**Cover Letter to Submission - State Significant Development (SSD-81767963)
Mixed Use Development 17-24 Loftus Crescent Homebush (SSD2025.2009)**

Strathfield Council Draft Submission to State Significant Development (SSD-81767963) Mixed Use Development 17-24 Loftus Crescent Homebush (SSD2025.2009) – 4 February 2026

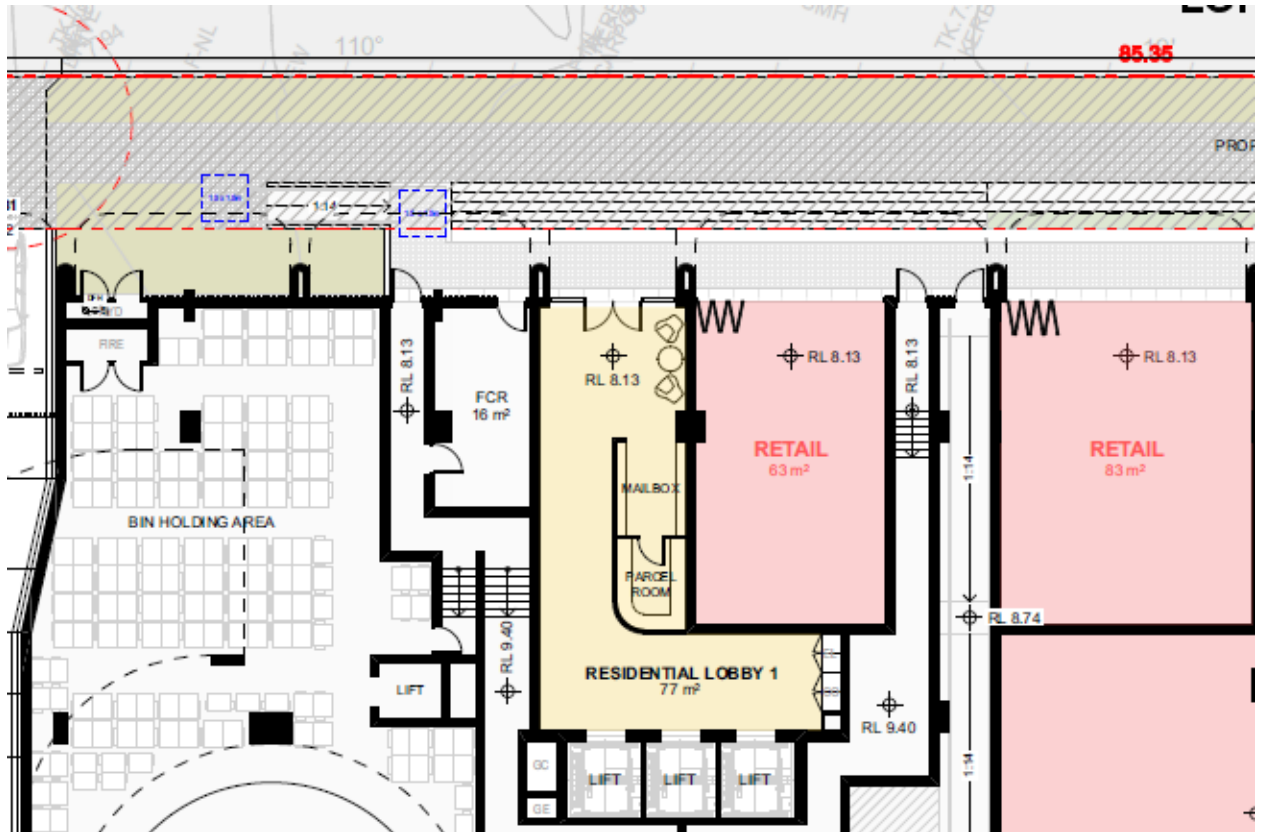
- Bin movement from Basement 1 collection point to Ground floor bin room seems to be inefficient operationally. A single lift to provide vertical bin movement seems like a sub-optimal strategy and requires a low-tech (not reliant of mechanical systems) to facilitate bin movement.
- To encourage greater active transport usage, Council requests the applicant to add a bicycle parking room on the ground floor in lieu of 1, or part of 1 retail tenancy (e.g. the westernmost 63m² retail space). This space should include bicycle fixing facilities, such as a bike stand, tire pump etc. This space should be dedicated to daily commuter users within the strata management plan.

- Lack of passive surveillance after business hours
Levels 1, 2, and 3 are dedicated entirely to vehicle circulation and parking. While active uses are provided at ground level, there is a concern that after business hours (6 pm–7 am) there will be no passive surveillance or “eyes on the street” to maintain public safety in the surrounding public domain.

The best practice is to provide apartment units to sleeve the car parking levels. At a minimum, this should be applied to the eastern frontage on Levels 1–3 to ensure habitable rooms or balconies overlook Subway Lane and its intersections with Loftus Crescent and Loftus Lane.

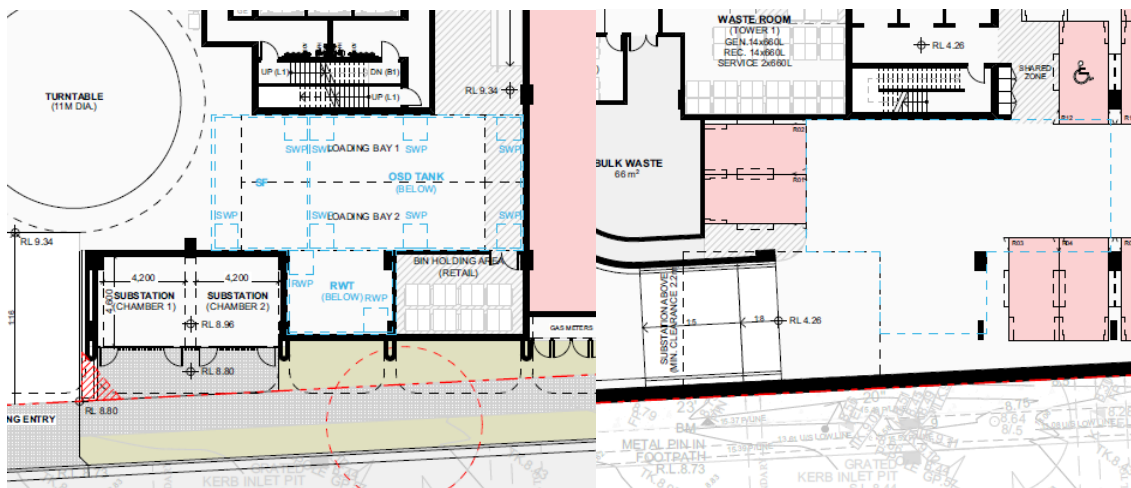
- Space adequate for OSD tank is questioned since it is shown dashed on the Ground Floor Plan and is not shown correspondingly on the Basement 1 Floor Plan. The floor-to-floor heights on the Ground floor are generous and could more easily accommodate the tanks. Alternatively, due to the surplus provision of car parking spaces OSD and water re-use tanks could be located within parking spaces.

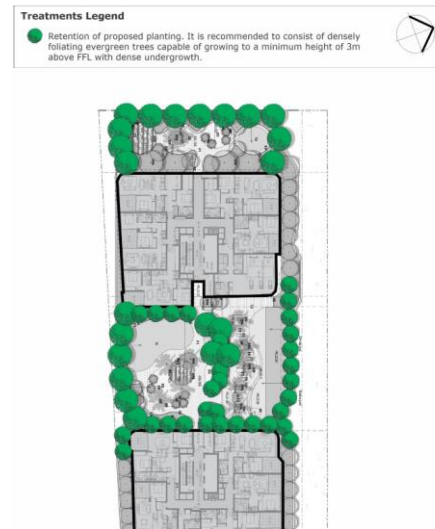
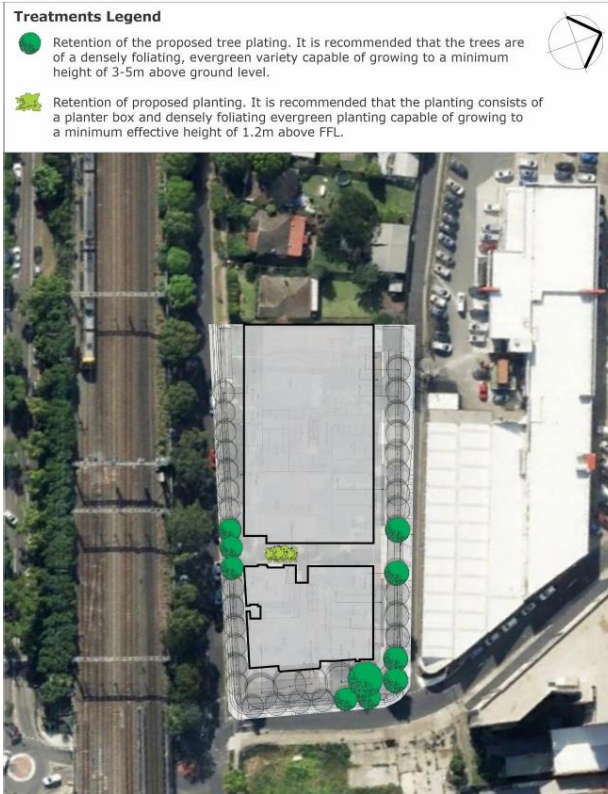
- The pedestrian wind study does not mention the downwash effect tall building induce and any mitigation measures within the private and public domains when proposing buildings of these heights. The study should encompass downwash effects including directional wind for a composite and complete analysis.
- Council encourages the applicant to consider adding glass or similar awnings around the perimeter of the towers within the podium level communal open space and within revised property boundary. This is to prevent falling objects from balconies injuring users whilst deflecting downwash wind away horizontally.

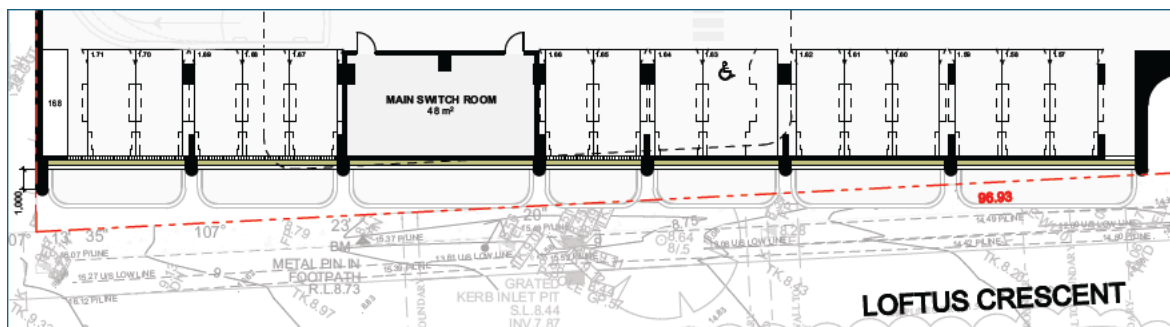
- Inadequate planter dimensions
The proposed planters along the building frontage on Levels 1–3 do not have sufficient dimensions to support planting on structure. In some areas, the width is approximately 300 mm (see example in screenshot below).

Increase planter width to a minimum 1000 mm to ensure adequate soil volume for establishing and supporting landscape planting, consistent with the landscape effect shown in the proposal's 3D renders.

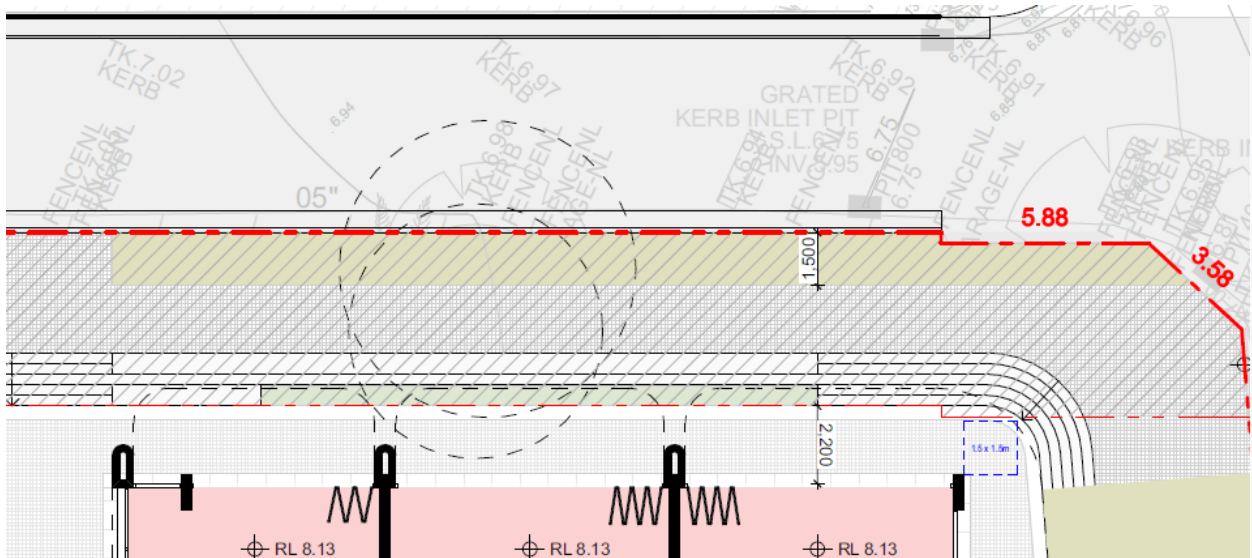
The Architectural plans show that the section of Loftus Lane for the length of the property line has been set back for Road widening.

The Loftus Lane frontage requires re-design to comply with the above requirements. The structures shown encroaching beyond the required setback and dedication must be removed and designed into the site boundary that results after the required setback and dedication has been achieved. In this instance stairs, ramps, raised planter boxes and overhanging awnings are to be removed.

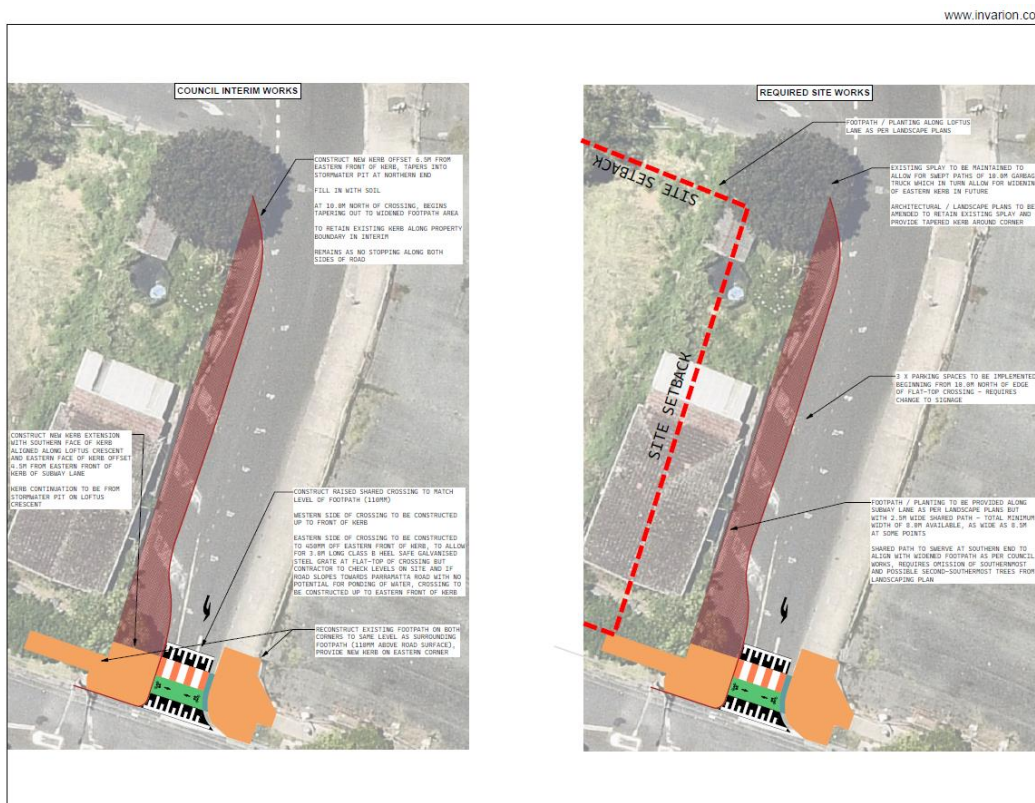
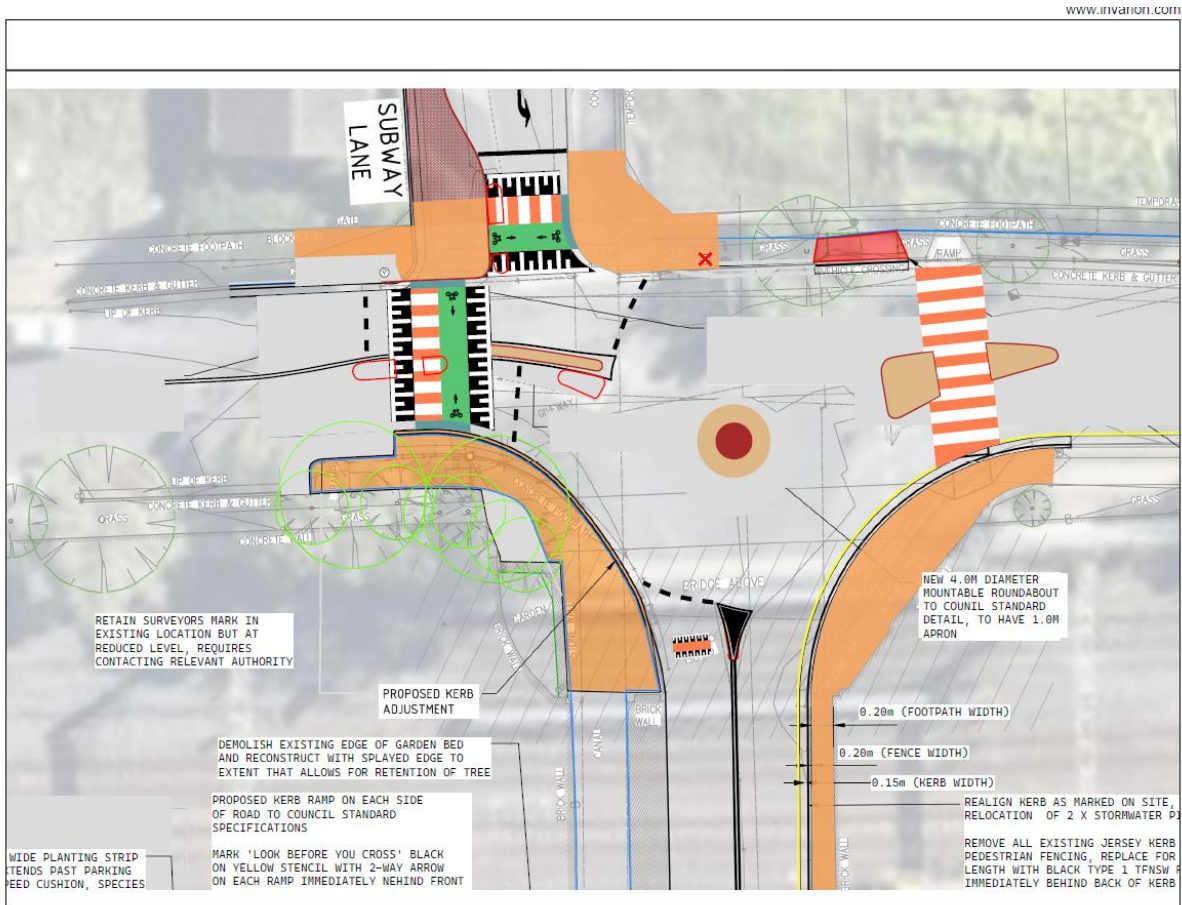
The Architectural plans show that the section of Loftus Lane for the length of the property line has been set back for Road widening under Council DCP. Additionally Subway Lane has also been set back to provide improved pedestrian footpath width. The basement is within the revised boundary alignment and does not encroach under or into the carriageway.

Since the existing Subway Lane road reserve varies in width from approximately 12m to 13m, and the defined future road reserve minimum width is 18.8m, the current proposal has not addressed the necessary setbacks, dedication and road reserve requirements for Subway Lane to be developed as a Neighbourhood Street.

Council requires the proponent to address the necessary design changes to ensure the 'Neighbourhood Street' road reserve, traffic lanes, footpaths and setback requirements are achieved for the future Subway Lane.

Extract of Loftus Crescent encroachments and access ramp

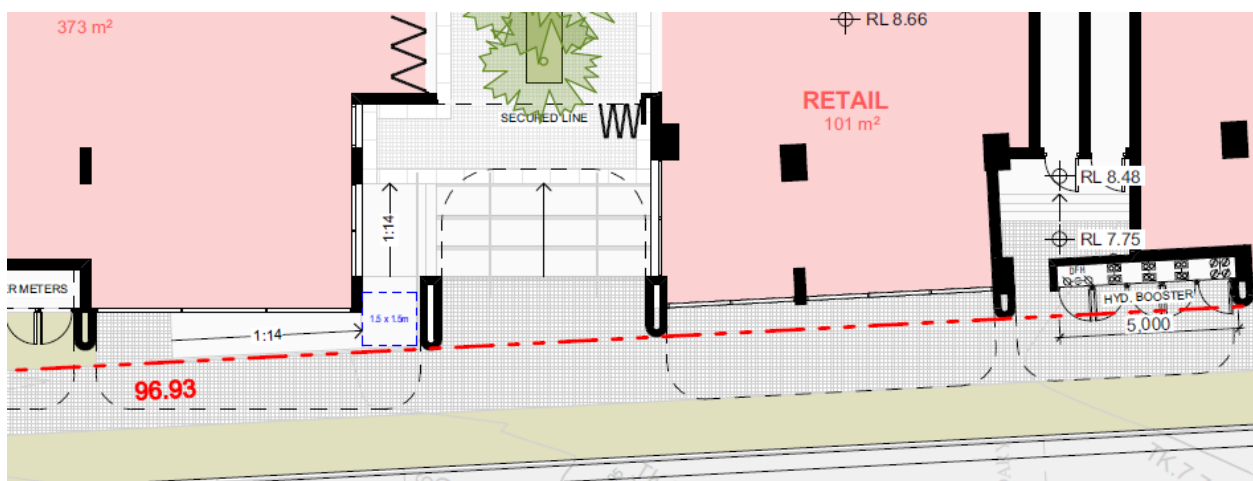
It is indicated on the survey plan (Appendix J – Survey Plan) that the distance from the brick wall defining the northern extent of the Main Western Railway Line and the southern boundary of the properties fronting Loftus Crescent is approximately 16.3m. Since the existing road reserve is approximately 16.3m and the defined future road reserve minimum width is 18.8m the current proposal has not addressed the necessary setbacks, dedication and road reserve requirements for Loftus Crescent to be developed as a Neighbourhood Street.

The Loftus Lane frontage requires re-design to comply with the above requirements. The structures shown encroaching beyond the required setback and dedication must be removed and designed into the site boundary that results after the required setback and dedication has been achieved. In this instance overhanging awnings are to be removed. Additionally, the proposed access ramp along this frontage must retain a AS/NZS standard compliant width for the full length of the ramp and not diminish in width along the angled shop frontage.

Council requires the proponent to address the necessary design changes to ensure the 'Neighbourhood Street' road reserve, traffic lanes, footpaths and setback requirements are achieved for the future Loftus Crescent.
